# UNITED STATES PATENT AND TRADEMARK OFFICE

APPLICATION NO.	FILING DATE	FIRST NAMED INVENTOR	ATTORNEY DOCKET NO.	CONFIRMATION NO.
10/590,229	06/28/2007	Elizabeth Rajan	14283.0013USWO	6747
23552 7590 06/22/2009 MERCHANT & GOULD PC P.O. BOX 2903 MINNEAPOLIS, MN 55402-0903				
EXAMINER				
TREYGER, ILYA Y				
ART UNIT		PAPER NUMBER		
3761				
MAIL DATE		DELIVERY MODE		
06/22/2009		PAPER

### Office Action Summary

**DETAILED ACTION**

FIG. 9

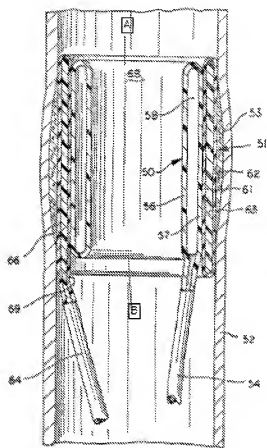
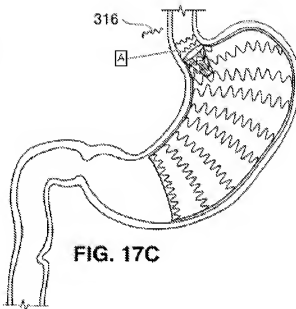
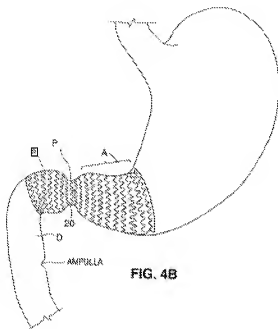
16. In Re claim 1, Rockey discloses a sleeve unit insertable in a natural body vessel (Abstract, lines 2, 3) capable of being used as a gastro-intestinal device (Col. 2, lines6-8), comprising:

a sleeve 51 (Fig. 9) that is a gastric bypass having an inlet A (Fig. 9) and outlet B (Fig. 9); and

an expandable inflatable balloon 50 (Fig. 9) attached to the gastric bypass (Col. 5, lines 64-68).

Rockey does not expressly disclose the gastric bypass comprising a permeable material; an esophageal extension; and a bowel extension.

Stack teaches a gastric bypass comprising material that allows the substances to pass from the reservoirs into the surrounding tissue (page 2, [0039], lines 9-11); an esophageal extension A (Fig. 17C); and a bowel extension B (Fig. 4B).

It would have been obvious to one having ordinary skill in the art at the time the invention was made to supply the apparatus of Rockey with the permeable material, an esophageal extension and a bowel extension, as taught by Stack in order to utilize the bypass of the conventionally known type.
